"My Home"

ADDENDUM TO DEVELOPMENT APPLICATION REPORT

DA Ref No.: 5.2024.93.1

LOTS 1004 & 1005, NO. 6 RALEIGH STREET, AND NO. 45 BISHOPSGATE STREET, CARLISLE
18/07/2024

The proposed design

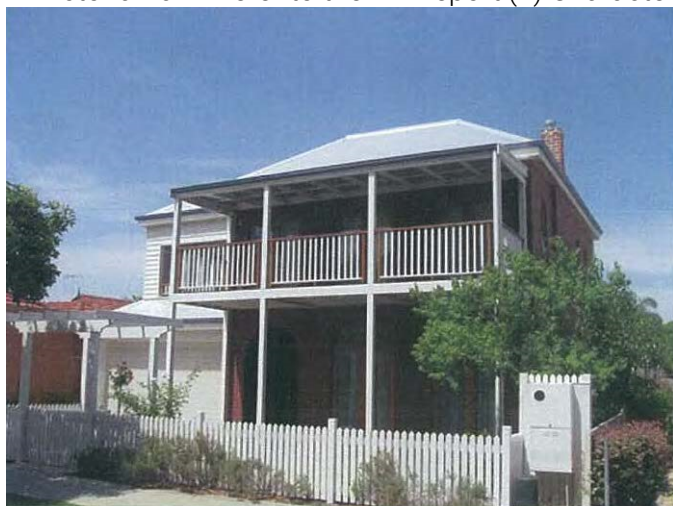
10) Design and response to context

Our design responds to these early housing examples as a historical connection through the decades of evolving housing style in Victoria Park. The development design is the

product of a skilled, judicious design process that results in attractive and inviting buildings and places that engage the senses.

The design has been rigorously explored to achieve a balance of scale, massing and built form which compliments the surrounding dwellings whilst making a conscious improvement on the aesthetic of the surrounding suburb.

There is a variety of built forms and an eclectic use of materials and styles over decades of housing development within the Town of Victoria Park and the suburb of Carlisle. Similar to other housing in the area, the proposed development represents appropriate materials and style of its time whilst making a strong connection to the original housing in Victoria Park. Refer to the DA Report (1) Character and Context.
